THE GREAT AMERICAN SOUND COMPANY

SERVICE TECHNICAL BULLETIN

NO. 36

MODEL TEALIA (801)

U22U

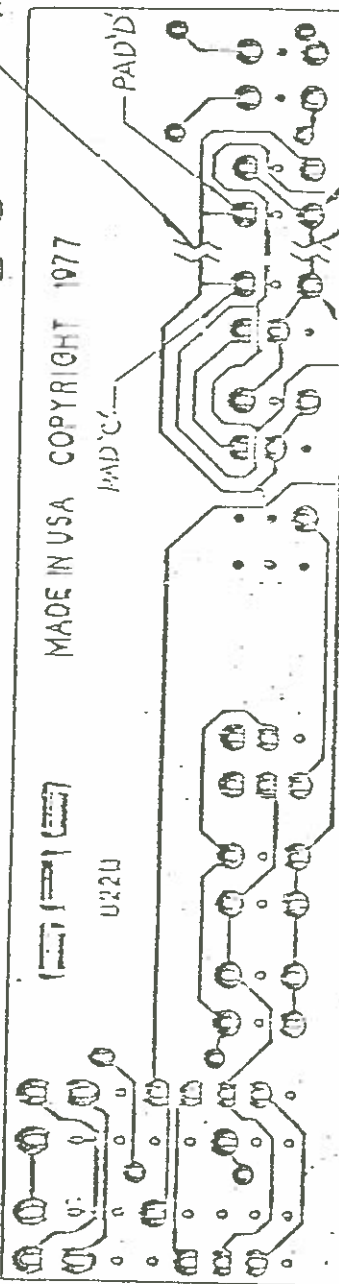
When pushing Channel A bottom Mode Switch, Channel B is heard; when pushing Channel B bottom Mode Switch, Channel A is heard.

Reversed connections to Mode Switches.

Interchange connections on Switch PC Board.

1. Remove top cover and place at side of unit.
2. Refer to pictorial supplied for location of switching PC Board #322 circuitry.
 - A. Cut foil at points 1 and 2.
 - B. Add jumpers between points C and E, and points D and F.
 - C. Interchange the wires between points A and B.
3. Replace top cover.
4. Turn on unit and check for proper operation.

CORRECT WIRE COLOR SHOWN

JUMPERS : C TO E
D TO F
